COUNCIL ASSESSMENT REPORT

NORTHERN REGIONAL PLANNING PANEL

PANEL REFERENCE & DA NUMBER	PPSNTH-177– DA22/0515
PROPOSAL	Demolition of the existing structures on the site, construction of two (2) an eleven (11) storey residential apartment buildings comprising 110 residential units, basement and ground level parking, swimming pool, provision of services, landscaping and lot consolidation
ADDRESS	Lots 8, 9, 10 & 11 DP 224382 and Lot 24 DP 776673 13-19 Enid Street, Tweed Heads
APPLICANT	Zone Planning Group Pty Ltd
OWNER	Pinnacle Properties (Aust) Pty Ltd
DA LODGEMENT DATE	4 August 2022
APPLICATION TYPE	Development Application - Integrated and staged
REGIONALLY SIGNIFICANT CRITERIA	Section 2.19(1) and Clause 2 of Schedule 6 of <i>State Environmental Planning Policy (Planning Systems) 2021</i> declares the proposal regionally significant development as it proposes a development with a CIV of more than \$30 million. The application is also regionally significant development pursuant to Cause 3 of Schedule 6 in that the Council is the owner of some of the land on which the development is to be carried out (Lot 24 – sewer relocation) and has a CIV of more than \$5 million.

Figure 16: Proposed Street interface of the Development (Source: Jackson Teece, 17 June 2022)

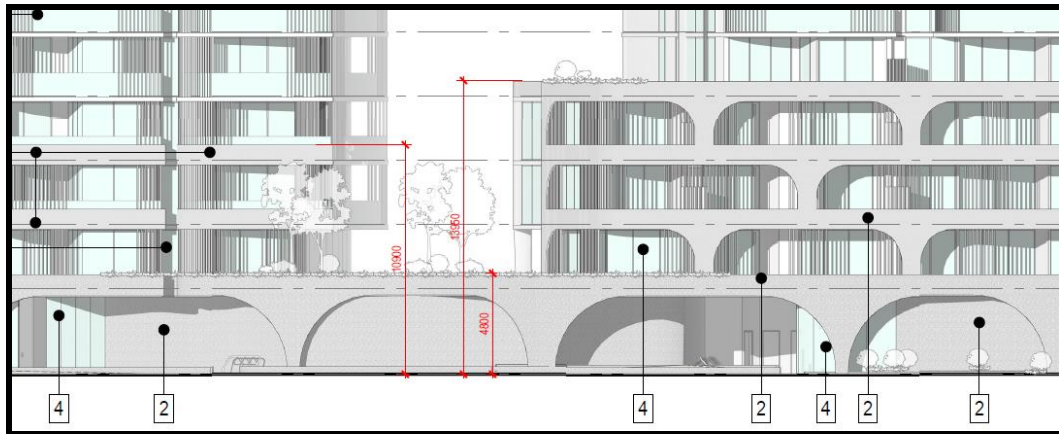
development, particularly in city centre locations. For the proposed development, there are significant concerns with the relationship of the proposed building to the street and the associated pedestrian entry and amenity aspects of the proposal. Parts 3D and 3G of the ADG provide controls for the public domain interface and pedestrian access which are considered below (**Figure 16**):

The street address to the park is similarly poor, with the continuation of the high blank walls as well as the lack of any habitable spaces or glazed areas existing along this southern frontage of the site.

Accordingly, it is considered that in this case, a street address and a prominent and legible entry area in the building façade have not been provided arising from the high blank stone walls proposed at ground level enclosing the on grade car parking, the lack of any ground floor apartments and habitable rooms with clear glazing or entry and lobby areas visible from the street frontage. The proposed development does not provide a clear street address and direct pedestrian access of Enid Street is not provided.

Figure 20: Street frontage height - Figure 3-7 of the DCP (Source: TDCP 2008)

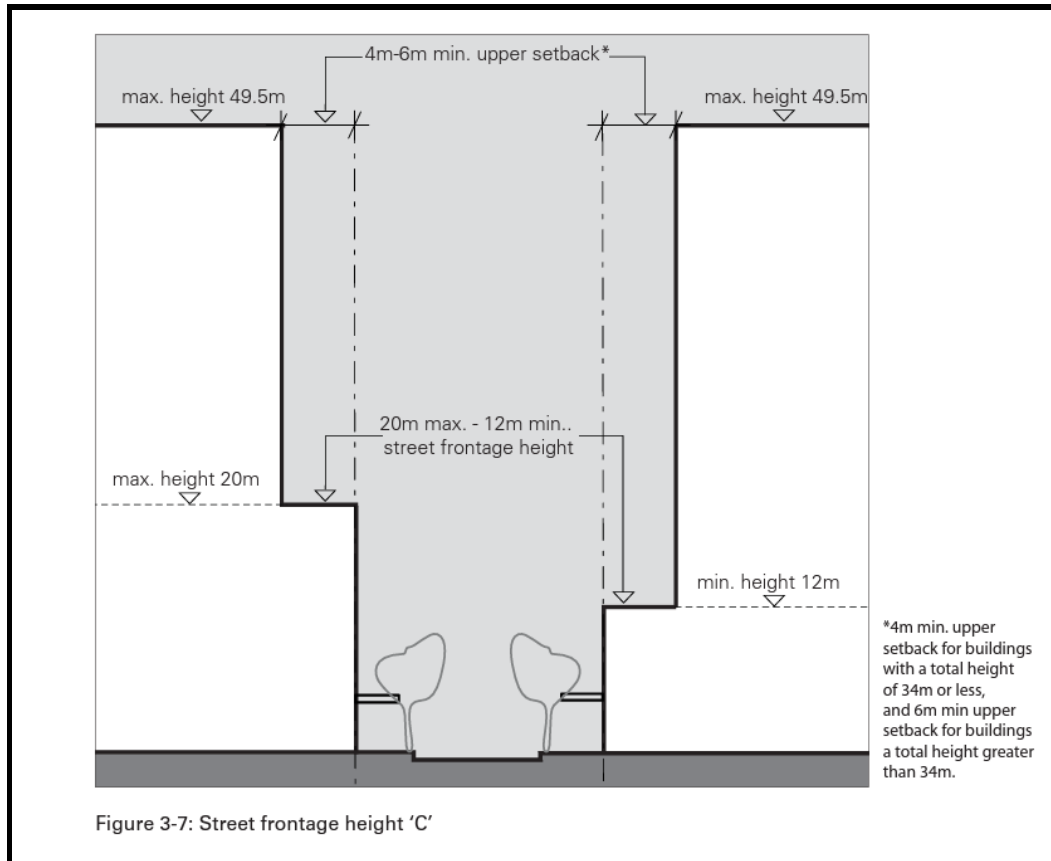
The controls pursuant to Section B2.3.2(a) outline the street frontage heights for the site, stating that the site is subject to the Street Frontage Height C applies as illustrated in Figures 3.4 and 3.7 of the DCP (**Figure 20**). The street frontage height for the site is to be between 12 metres and 20 metres, with an upper setback 6 metres for buildings with a total height of greater than 34 metres.

The proposal is also inconsistent with objective (2) in that a comfortable street environment for pedestrians in terms of daylight, scale and sense of enclosure has not been provided given the lack of an adequate upper setback which places a high proportion of the building's bulk at the street, which also arises from the inconsistency with the predominate front setback. It is also considered that potential wind tunnel impacts of the proposal have not been adequately demonstrated and there is a lack of space at the street for large trees to be planted which would complement the streetscape.

The proposed building form, with its inconsistency with the upper-level setback of the street frontage height controls is considered to be unsatisfactory and is inconsistent with the objectives of Section B2.3.2 of the TDCP 2008.

Figure 21: Building bulk and depth controls (Source: Figure 3-11 of Part B2 of the TDCP 2008)

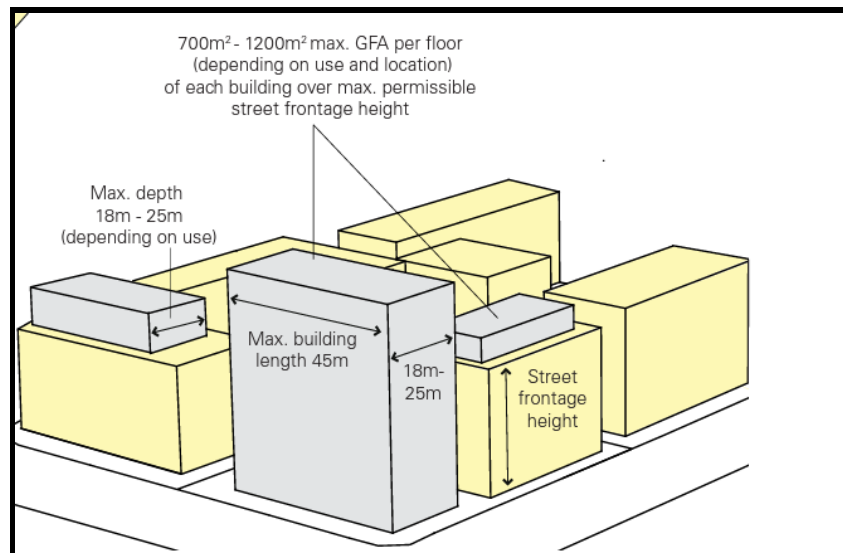
There are a number of building depth and bulk controls pursuant to Section B2.3.3(a) of the TDCP 2008 which apply to the proposal including maximum GFA per floor above the street frontage height, building depth and building length (**Figure 21**). The proposal complies with the building length and maximum GFA per floor, however, does not comply with the building depth control of 18 metres. The floor plate of both towers exceeds this building depth, primarily in the eastern section of the north tower and the western section of the south tower.

The inconsistencies with the building depth control results in a building which includes numerous apartments with internal rooms which adversely impacts on the internal amenity of the proposed apartments. This excessive building depth also increases the bulk and scale of the building form, particularly when viewed from adjoining properties and the public domain, and contributes to view loss for adjoining properties to the west. Overshadowing is also potentially increased due to the building depth exceeding 18 metres.

Figure 22: Proposed ground level setback to the northern adjoining site (Source: Jackson Teece, June 2022)

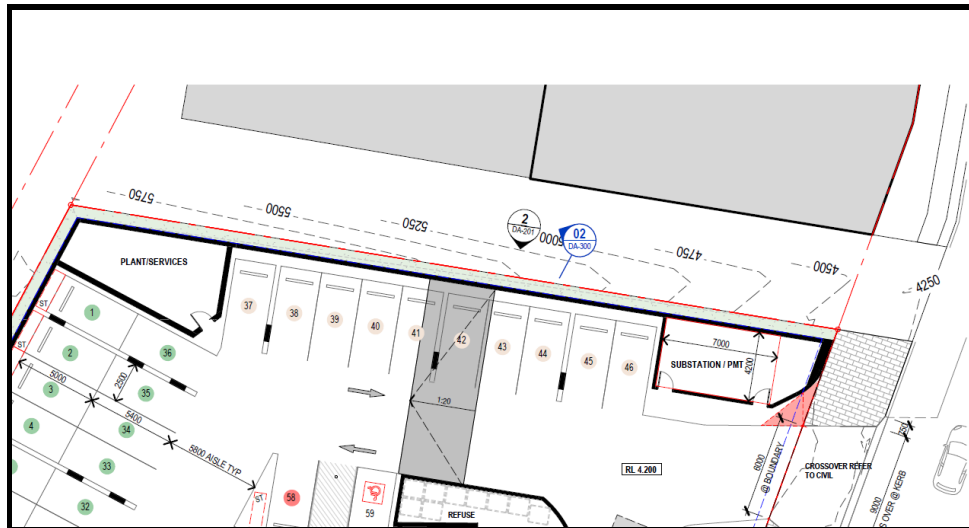
The proposed development provides a setback to the northern site boundary of approximately 700mm at ground level, adjoining the boundary with the Bay Grand development (**Figure 22**). A 2 metre (approx.) high wall exists along the majority of the boundary with Bay Grand, with an open area existing at the street boundary which includes an electrical substation and other infrastructure (**Figure 23**). Given the setback proposed for this current development, this will result in a 'gap' between building structures of approximately 700mm wide, which will become a narrow and unusable area.

There were concerns raised in the submissions that this area could become an area for anti-social behaviour. Furthermore, it is considered that this area will be difficult to maintain given the small gap within which maintenance could be carried out.

Figure 24: Proposed Apartment Type 3B (same for 2C and 4A) with small style snorkel windows to qualify as an external wall (Source: Jackson Teece, June 2022)

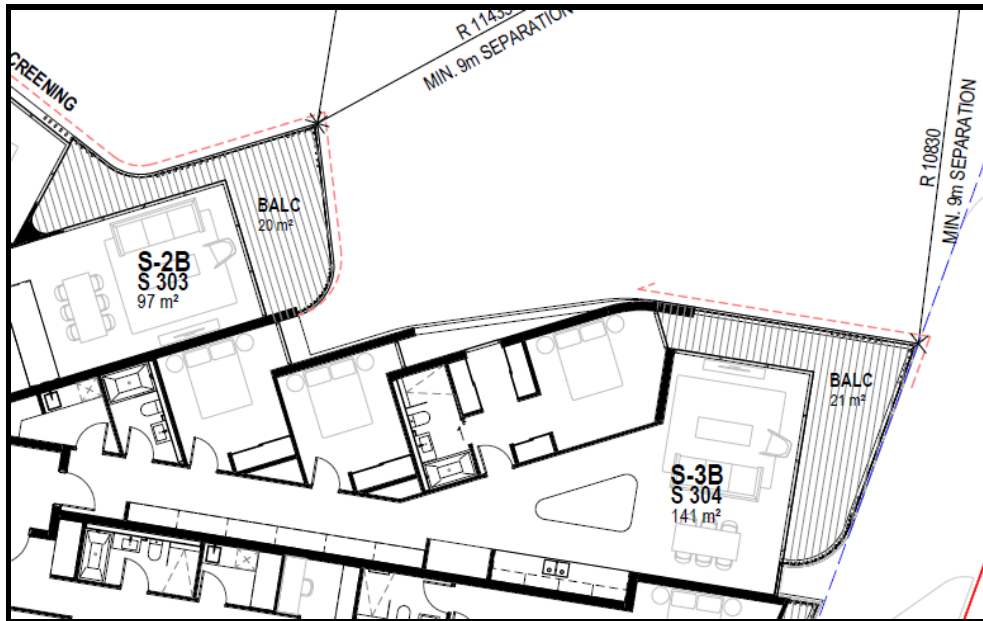
- (b) Kitchens in circulation spaces - Proposed apartment types S-3B and S-2C in the south tower include kitchens located in the circulation space/hallway, contrary to Part 4D-1 which requires that kitchens should not be located as part of the main circulation space in larger apartments (such as hallway or entry space) ((total – 9 units).
- (c) Kitchens more than 8 metres from a window – Proposed Apartment type N-2C is 8.3m to the back of kitchen to a window contrary to the design criteria 2 for Objective 4D-2 to maximise the environmental performance of the apartments (total – 9 units).
- (d) Living areas and bedrooms located on the external face of the building - Proposed Apartment types S-3B, S-2C and S-4A in the south tower comprise bedrooms which

rely on a very small, snorkel type window to achieve compliance with this control which is unsatisfactory (**Figure 24**).
